CABINET MEMBER FOR HIGHWAY MANAGEMENT – 24 FEBRUARY 2022

HARWELL: B4493 AND ADJACENT ROADS - PROPOSED 20MPH SPEED LIMIT ZONE & TRAFFIC CALMING MEASURES

Report by Corporate Director, Environment and Place

Annexes Annexe 1 Consultation Plan

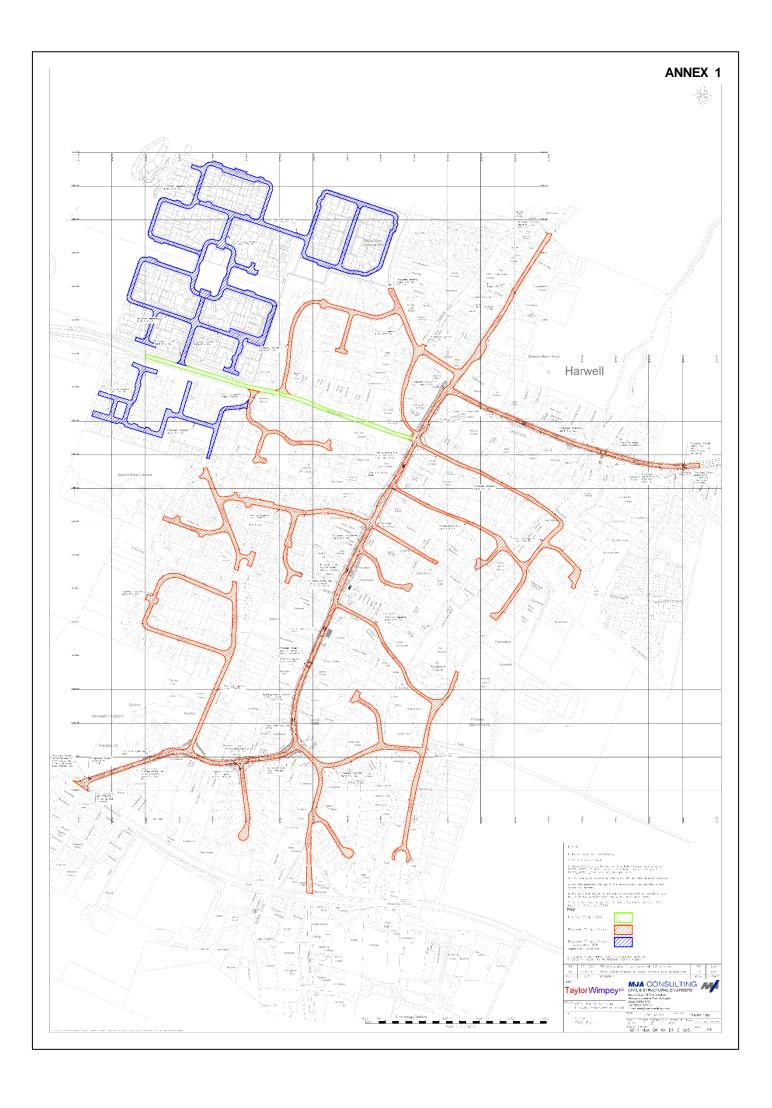
• There appear to be gaps in the ACL's – is this correct or an error in the plans? If correct then this is unacceptable.
	Gaps in ACL's are not safe or practical and if a continuous ACL can not be installed, then there should be no ACL's at all. Example on the High Street.

• The proposed raised table at Tyrrells Close junction seems to be poorly positioned. There are bus stops on either side of the road – will the footway and kerbs be raised to maintain easy access to buses for disabled users? Will the bus be stopping half on and half off of the raised area?
	In summary, please consider my safety concerns with the current proposals, but most importantly, revise the plans to include the Reading Road which has the most significant road safety issues in the village.
	20mph speed limit - Object Raised tables - No opinion Build-out feature - No opinion

Build out feature: I assume this means the part near the war memorial? The drawings are not very detailed so it is difficult to understand how far this build out extends to. Does it negatively impact on-street parking for the Almshouses and nearby? Currently there are a significant number of cars that park on the high street in this area as the houses in that area do not have off-street parking, so this will reduce the amenity for those properties. In addition it will reduce access and parking for the Orchard house – the care home which already suffers from parking issues.
	In summary I am all for making the village safer, but if by doing so you remove accessibility and parking for local residents it isn't really improving the village for us. This particularly seems to negatively impact those of us living in the older houses on the high street. Had you considered instead narrowing the roads, building out features which include parking and putting tighter restrictions on the weight and size limits of HGVs using the roads?

- 13. Noting the above, in respect of the concerns on the removal of the centre line on the High Street, the existing carriageway width is not being changed, with the current carriageway width being 'reallocated' to facilitate the 1.5m wide advisory cycle lanes, this arrangement has recently been applied to the Didcot/ Wantage Road in Didcot. If two buses or cars want to pass, then they can do so by moving into the cycle lane when safe to do so. This reduces vehicle speed and provides a safer space for cyclists. The junction tables will have on/ off ramp gradients of 1:16 which are judged to be bus friendly. However further discussions will be held with the bus operators on aspects of the detailed design.

- 15. Taking account of the above and other responses in respect of the appropriateness, safety, effect on parking and its overall traffic and environmental impact (including noise and vehicle emissions), a design review is taking place of the build-out outside the War Memorial.
